SERVICE AND PARTS MANUAL
MODEL 28A33,28A34,28A35,
28A37,28A53,28A55
FILMSTRIP/SLIDE PROJECTOR

A.V. SERVICE BULLETIN NO. 1978-3

MODELS AFFECTED: Silent Filmstrip – 28A33, 28A34, 28A35, 28A37, 28A53, 28A55, 28A56, 28A75.

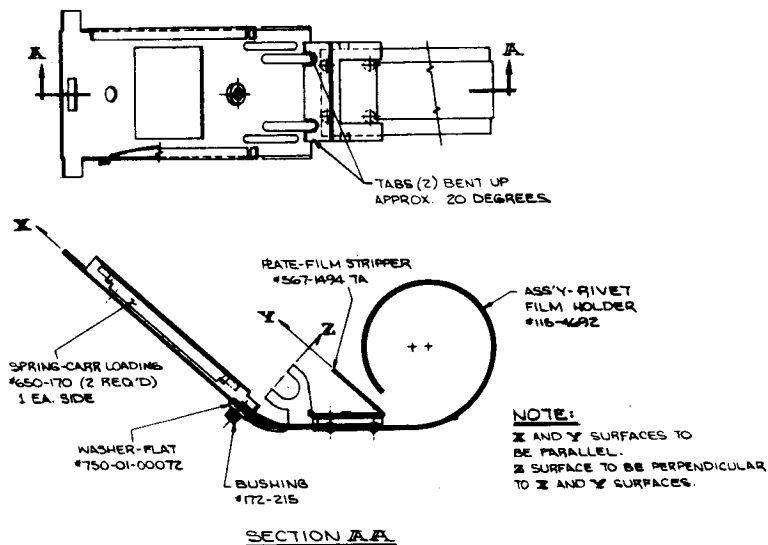
PROBLEM: Difficulty with inserting film into film carrier or film sprocket.

The film carrier aperture glass beveled edges must face each other. Chipped or improperly beveled glass should be replaced.

The film carrier holder shape should conform to the drawing below. The surfaces X and Y should be parallel and the Z surface perpendicular to the X and Y surfaces. The two tabs on the film stripper plate should be bent to approximately a 20 degree angle. If this does not correct film jamming at the sprocket, then the film holder should be replaced with Part Number 115-5262. This assembly is complete with the parts shown on the drawing.

REMEDY: This problem can be caused by the film, film carrier, and film carrier holder.
